November 1, 2017

GZA File No: 01.00171521.15

Re: Release Abatement Measure Plan Modification No. 3  
Construction-Related Remediation Activities  
(Former) Everett Staging Yard  
1 Horizon Way  
Everett, Massachusetts  
Release Tracking Number (RTN) 3-13341

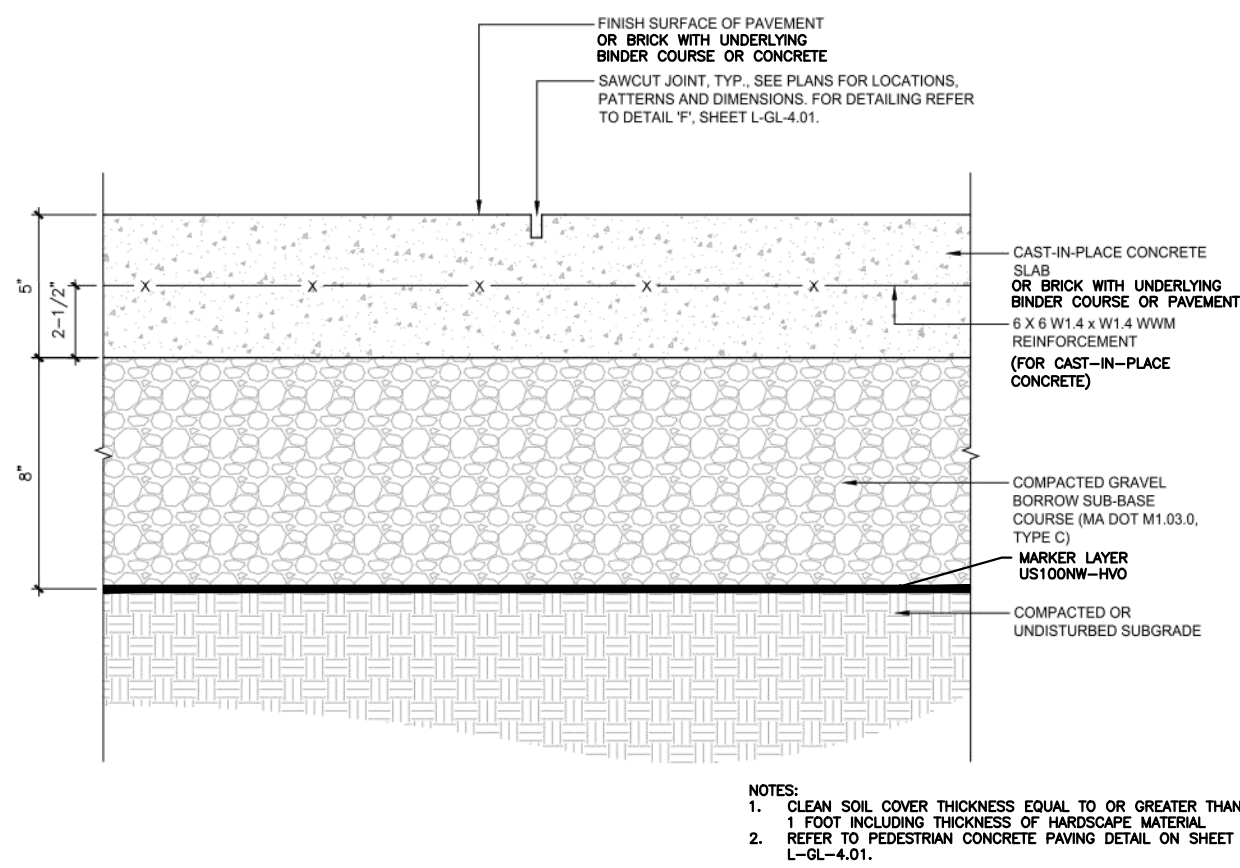
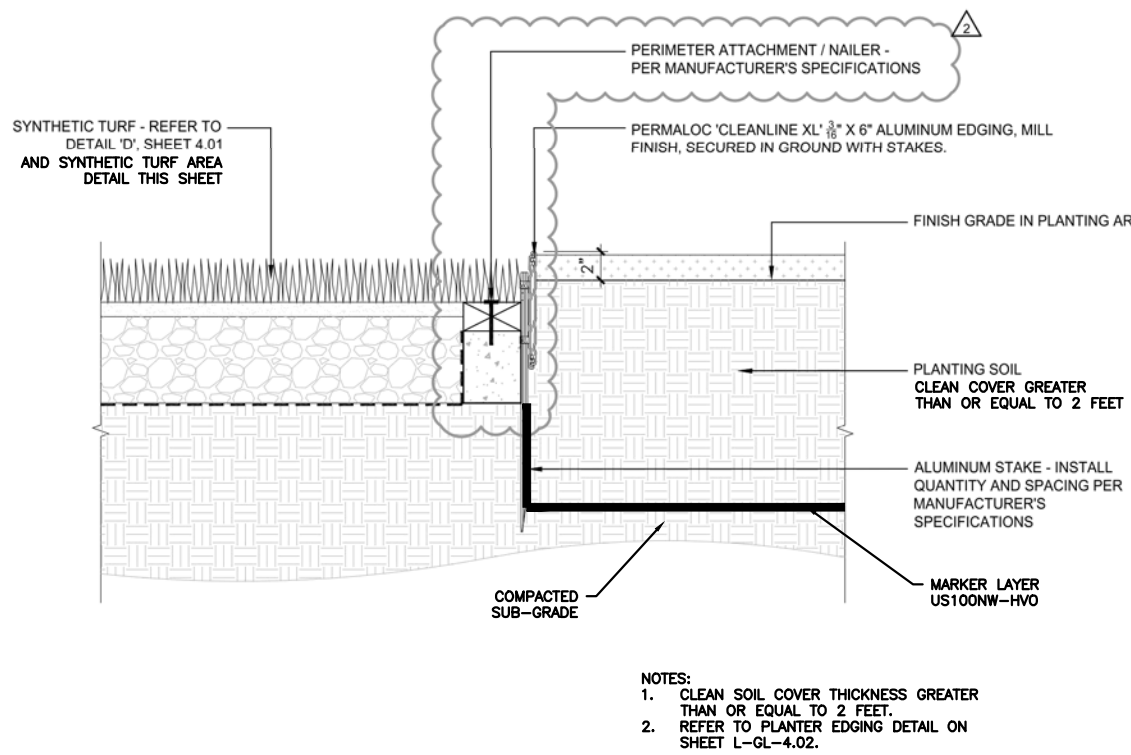
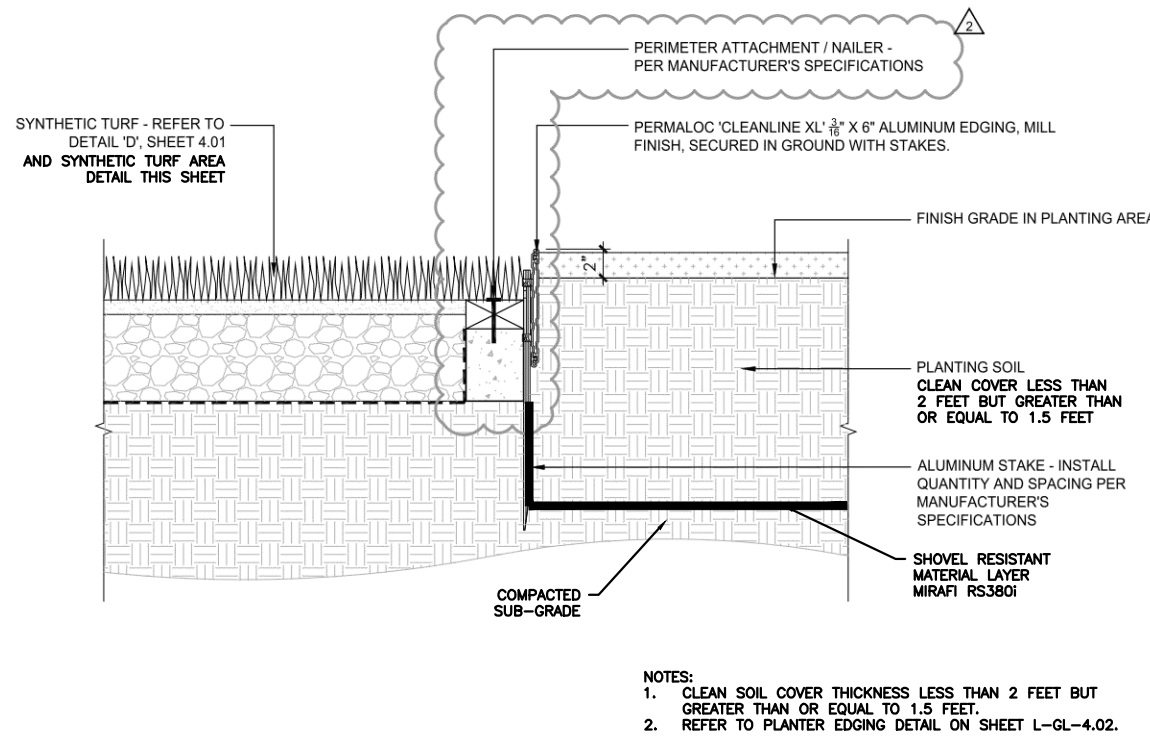
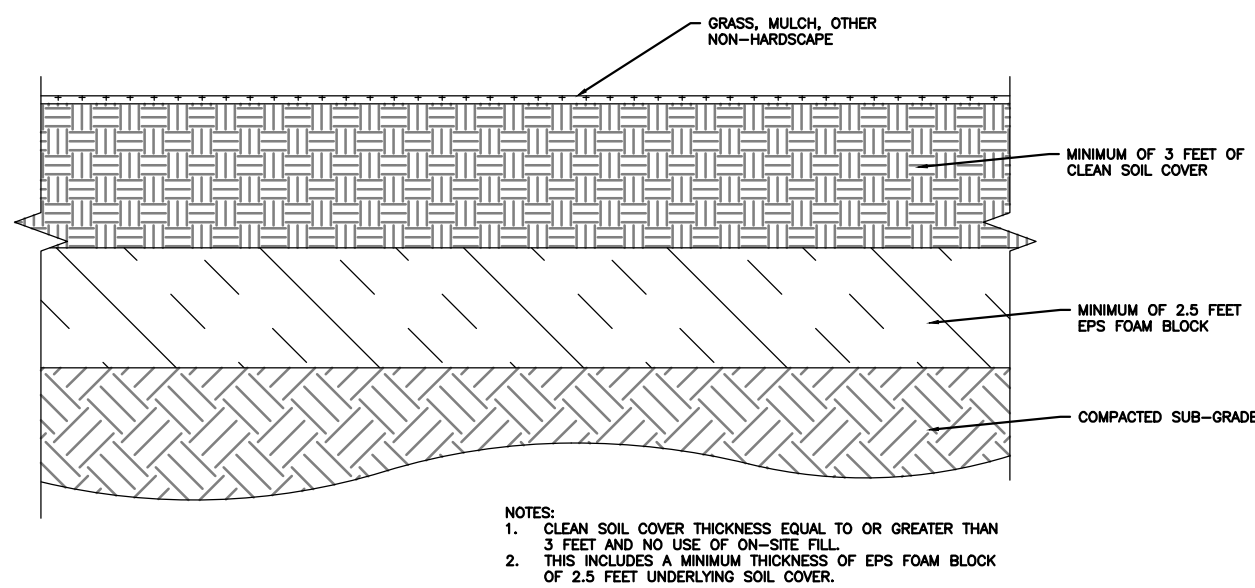
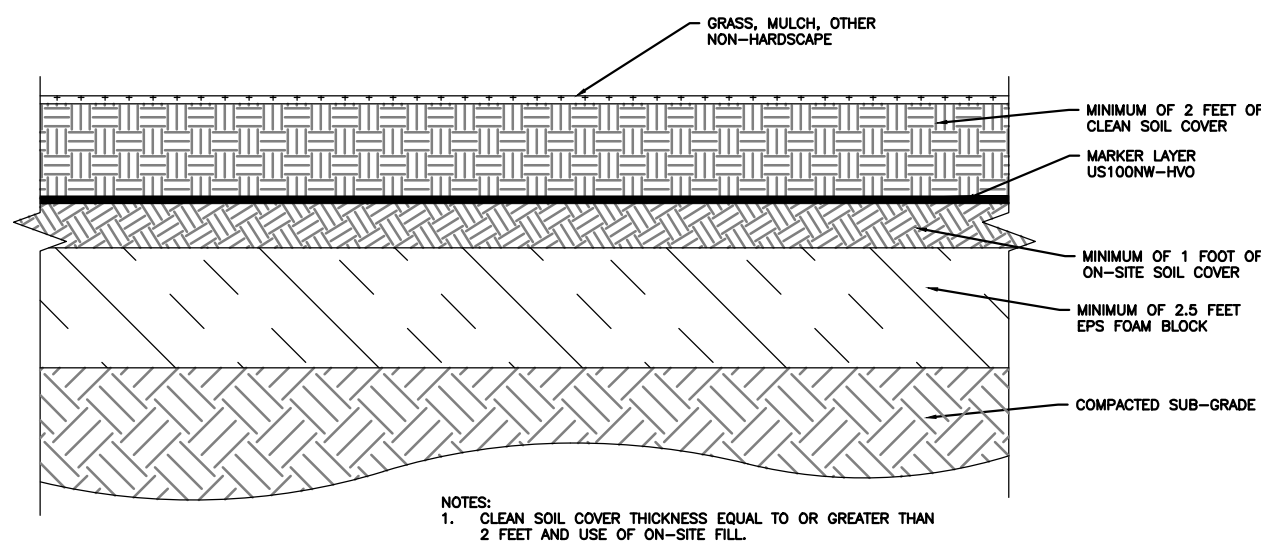
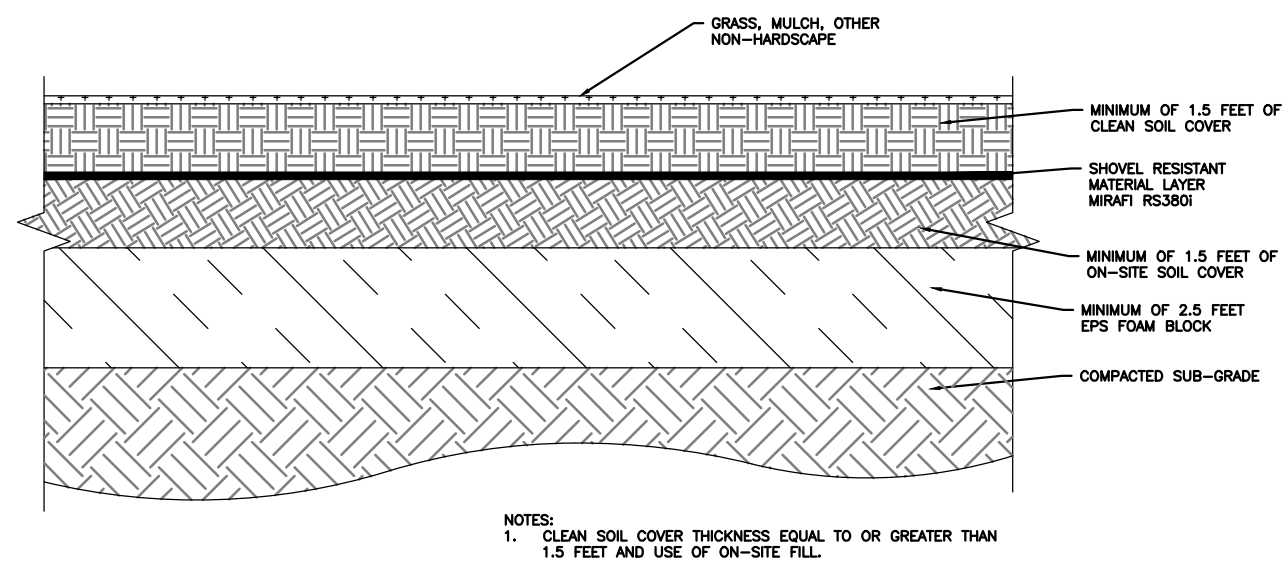
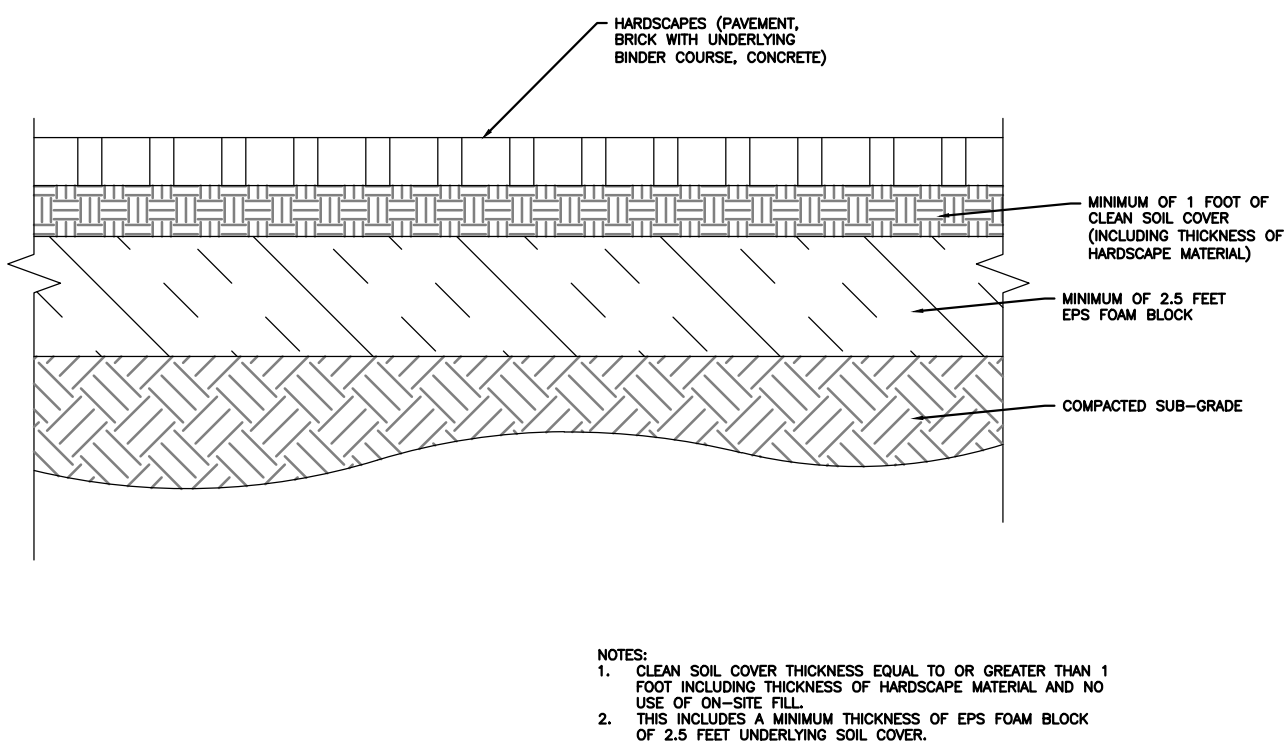
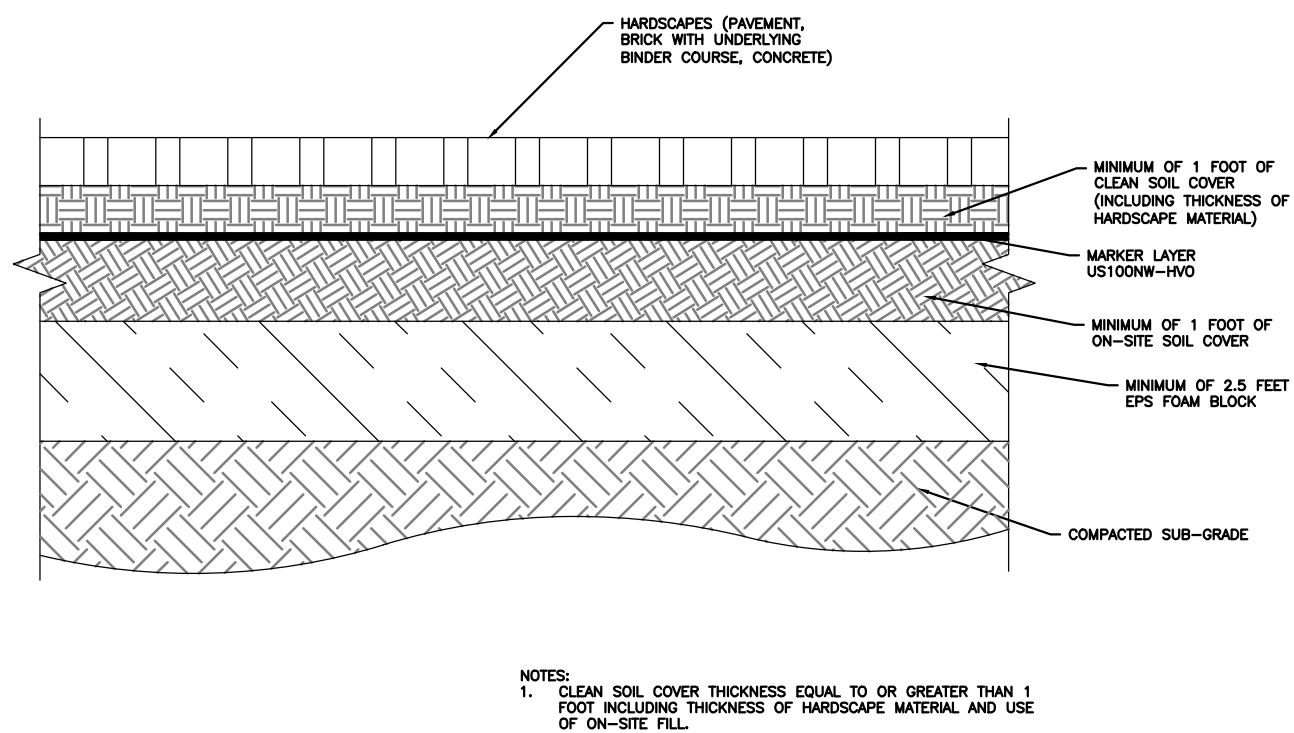
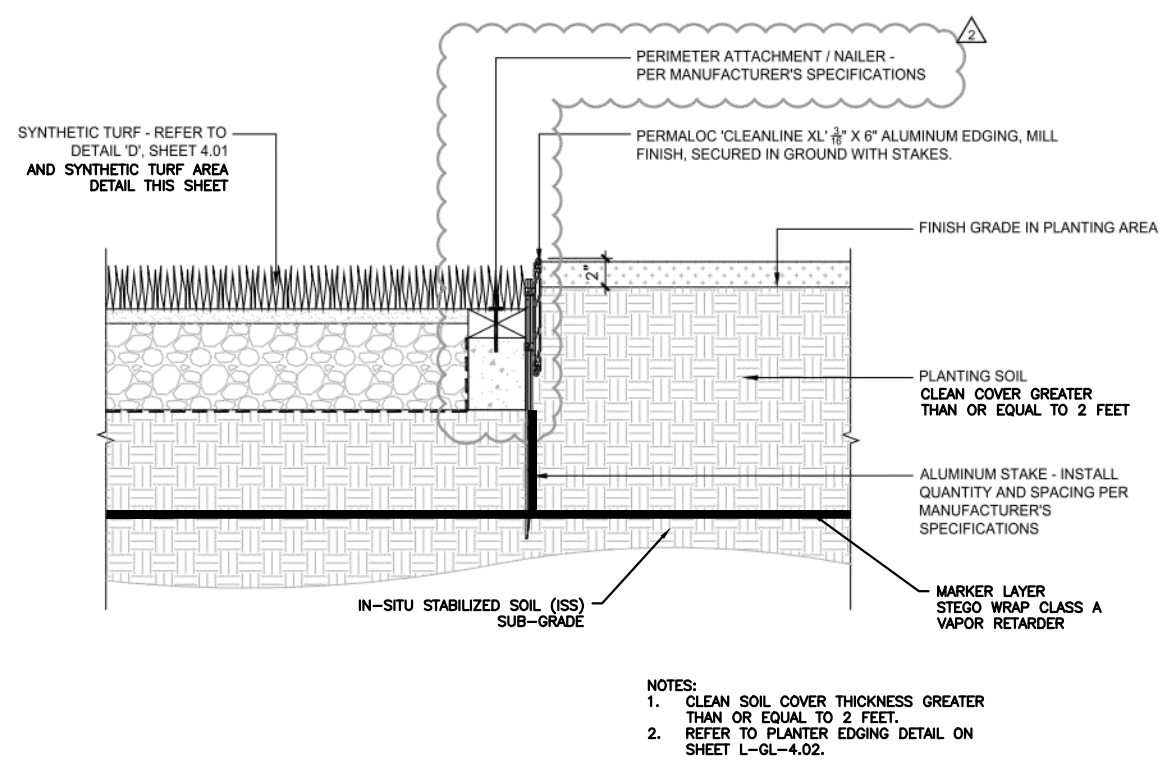
The proposed final surface of the Site consists of the following types of materials, depending on the proposed uses of specific areas: bituminous concrete, concrete, artificial turf, and landscaping materials. Engineering controls to be employed include soil and clean fill material of varying thicknesses, high visibility marker layers, shovel-resistant layers, and expanded polystyrene block (EPS block) material. A summary of these areas, including proposed site development over the In-Situ Stabilization Area (ISS Area) and the final surface material is described below. Please also refer to the attached **Figure 3** entitled “Clean Soil Cover Options” dated September 2017 for cross-section details of the clean soil cover materials.

- **Roadways for vehicular traffic:** Finish material will be a minimum of 7 inches of bituminous concrete underlain by 12 inches of imported base course soils underlain by high visibility marker geotextile fabric (Detail B).

- **Sidewalks, walkways, and harborwalk for pedestrian traffic:** Finish material will be a minimum of 5 inches of concrete underlain by 8 inches of imported base course soils and 10 inches of clean granular soils underlain by high visibility marker geotextile fabric (Detail B). Some walkways (including the harborwalk) will consist of a minimum 3-inch brick asphaltic bedding material underlain by 3 inches of bituminous pavement and 18 inches of imported base course material.

- **Synthetic turf areas for public use/pedestrian traffic:** Finish material will be artificial turf underlain by a minimum 18 inches of imported turf support soils underlain by a high visibility, high durability geotextile fabric (Detail A). In areas where ISS materials are below artificial turf, the turf support soils will be a minimum of 24 inches thick and will be underlain by a high visibility polyethylene sheeting to promote collection and drainage of irrigation/precipitation water. For this area, the artificial turf has been determined by MassDEP to meet the requirements of a shovel-resistant layer.

- **Landscape areas:** Finish material will be natural grass and/or other landscape materials (mulch, stone, etc.) with shrubs/trees. Some areas may include a minimum of 18 inches of soil/stone below finished grade underlain by a shovel-resistant geotextile material (Detail D). Other areas will have a minimum of 24 inches of soil/stone below finish grade underlain by a high visibility geosynthetic fabric (Detail C).

- **Landscape areas over ISS Area:** Finish material will be natural grass and/or other landscape materials (mulch, stone, etc.) with shrubs/trees. Where landscape areas are present over the ISS, there will be a minimum of 24 inches of soil/stone below finish grade underlain by a high visibility polyethylene layer to promote the collection and drainage of irrigation/precipitation water (Detail J).

- **EPS Foam Block areas:** Finish materials will be natural grass and/or other landscape materials, concrete, or bituminous concrete. EPS Foam Block will be installed at a minimum thickness of 2.5 feet directly below the finish surface materials. The EPS Foam Block has been approved as a “marker layer” in and of itself if clean soils are placed over the EPS Foam Block (Detail E). If on-Site soils are used for some portion of the fill over the EPS Foam Block, then the cross-sections described as Detail F, Detail G, Detail H, and Detail I, as shown on **Figure 3**, will apply.

no marker or shovel resistant materials are proposed in the EPS Foam Block areas unless on-Site soils are used as part of the three to five feet of cover material described above. Refer to Details E through I on **Figure 3** for proposed EPS Foam Block clean cover sections.
